TENDER NUMBER: RFP082/2026

APPOINTMENT OF A CONTRACTOR FOR DRILLING AND GROUTING WORKS FOR THE TZANEEN DAM PROJECT

CLARIFICATION QUESTIONS: RFP082/2026

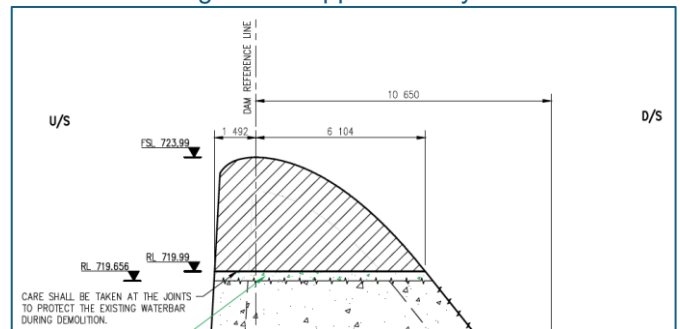
#	QUESTION	RESPONSE
1	a) Please confirm the size of drainage holes already drilled? b) Are these holes currently dry or if not which are leaking and how big is the leak? c) Can you confirm if cavities were intercepted in the currently drilled grout curtain holes? If yes confirm size of cavity. d) Can you please give the dimensions of the gallery. e) Is there ventilation and lighting in the gallery. f) Please show a photo of the entrance into the gallery is <u>access a walk in</u> entrance or is crane required for drilling equipment? g) Can water from the dam be used for Drilling and Grouting operations.	a) The existing drainage holes are 75 mm in diameter. b) The drainage holes are partially flowing. Seepage has been observed in approximately 4 holes with a strong flow of water into the gallery. Water is pumped from the gallery. c) Yes. Cavities were intercepted in the boreholes. Refer to the attached historical data for holes G1 - G11 for information on the cavities. d) The gallery has approximate internal dimensions of 1.5 m × 2.4 m.  SECTION 01-01 DETAIL OF GALLERY SCALE 1:20 e) There is ventilation available and there is no lighting in the Gallery. f) The gallery entrance is walk-in. Crane is not required for the mobilization of drilling equipment inside the gallery. A photograph of the entrance is attached below. g) Water for site use is extracted from the designated water extraction point located downstream of the dam wall at the stream low-level bridge (400 m distance from dam wall)
